UNIVERSITY PLACE

CDC Overview

September 28, 2021

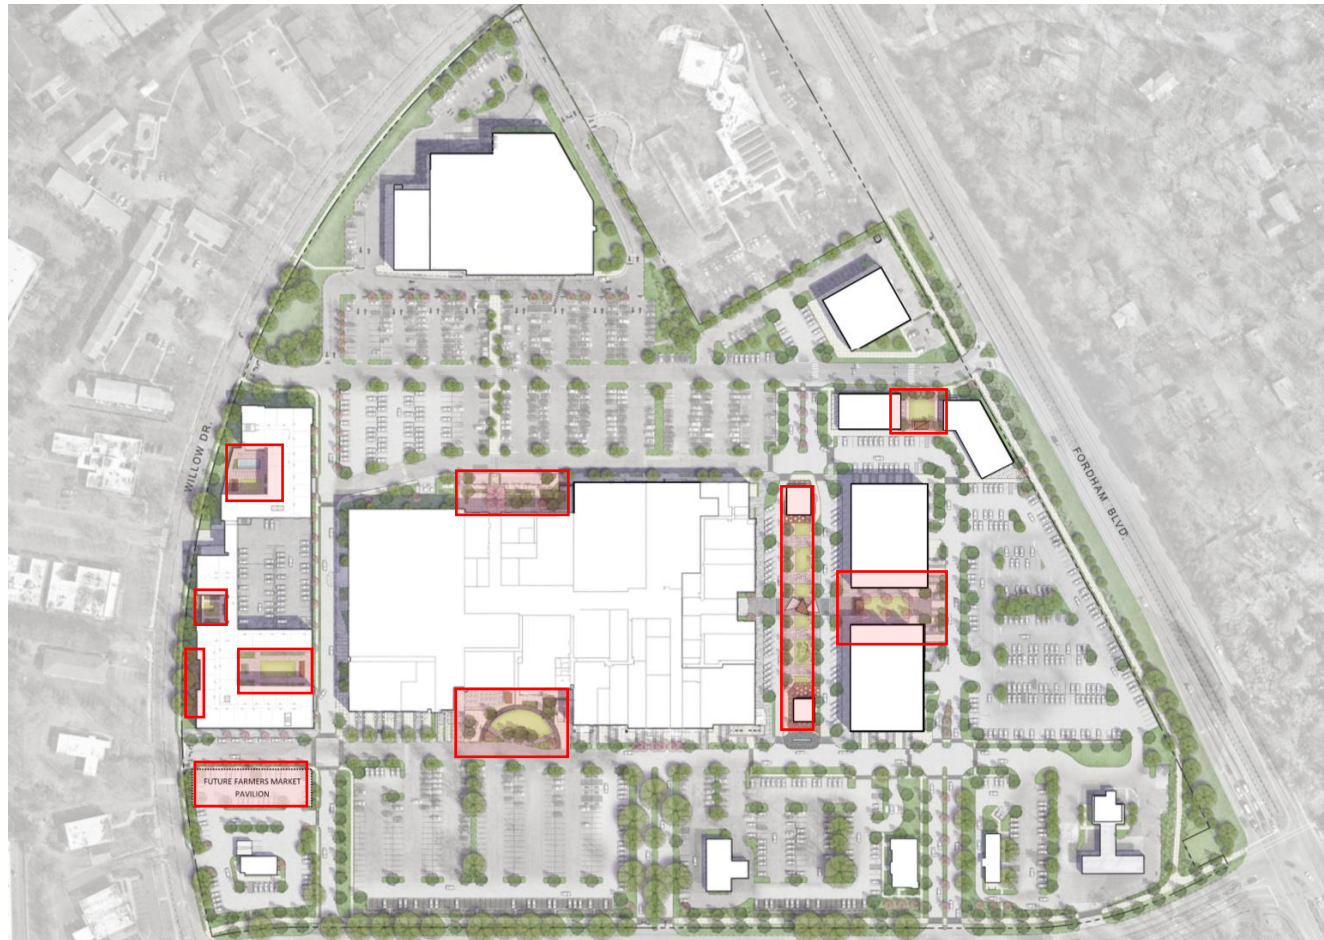
HEIGHT AND MASSING OF APARTMENTS NEEDS TO LOOK VERY DIFFERENT THAN OTHERS IN BLUE HILL DISTRICT

Reason for concern:

Apartment Height at Public
ROW - 90'

Minimal articulation

~5,700 SF of open courtyards

As Proposed:

Apartment Height at Public ROW:

Willow (North) - 59'

Willow (South) – 70'*

**Raised corner feature extends to 75'
As compared to 90' in example*

Existing mature trees to remain are similar height to building along Willow Dr. To help ensure trees remain healthy through construction, building is setback further (typically 30' - 40' from curb).

Building includes significant articulation along public ROW

Over 18,000 SF of open courtyards
As compared to ~5,700 SF in example
